16 March 2022

**RE: Telopea Concept Plan and Stage 1A Residential, Retail, Child Care and Aged Care –  
Adderton Road, Telopea – SSD-14378717  
Transport and Accessibility Impact Assessment Addendum**

The objective of this TAIA Addendum is to provide responses to the traffic and transport related RFIs received from City of Parramatta Council (Council), NSW Department of Planning, Industry and Environment (DPIE), and Transport for NSW (TfNSW).

## Attachment 2 – SIDRA Results, Adderton Rd / New Link Rd Intersection

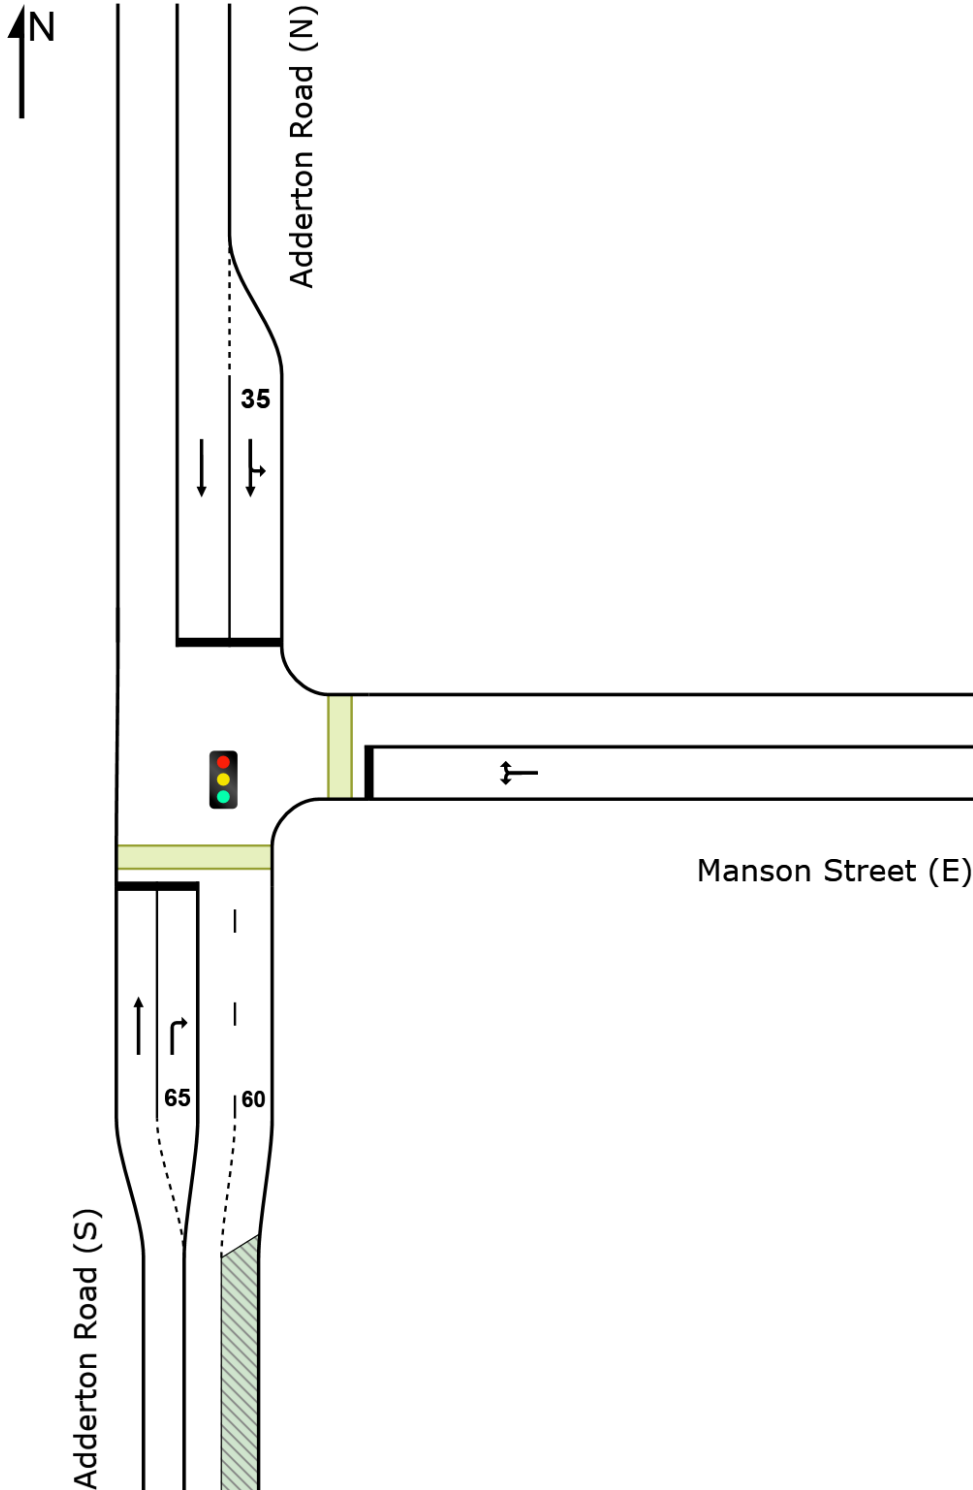
The SIDRA analysis at this intersection has been revisited to account for the 196 dwellings that were overlooked, and the additional 49 peak trips associated with these dwellings. Regarding this, it is noted the SIDRA results from the GTA studies indicate that only about 6% of development traffic would use the New Link Road, which appears reasonable having consideration that only 8% of traffic was expected to arrive from/depart to areas northwest of the Precinct, with the vast majority (66%) of traffic expected to arrive from/depart to areas to the south of the Precinct. Accordingly, only a small proportion of these 49 additional trips would be expected to use the intersection of Adderton Road with New Link Road.

**Table 4** presents a summary of the results of the latest SIDRA analysis for the intersection of Adderton Road with New Link Road; for comparison, the results from the 2021 TAIA are also presented.

As expected, the results of the SIDRA analysis for the current scheme (including all 4,700 residential dwellings) are materially the same as the 2021 TAIA results for the 4,504 dwellings scheme, and importantly the results confirm that the intersection is forecast to continue to operate satisfactorily with a level of service of D or better. Detailed results for the latest 2022 SIDRA analysis of this intersection are appended at **Attachment 2**.
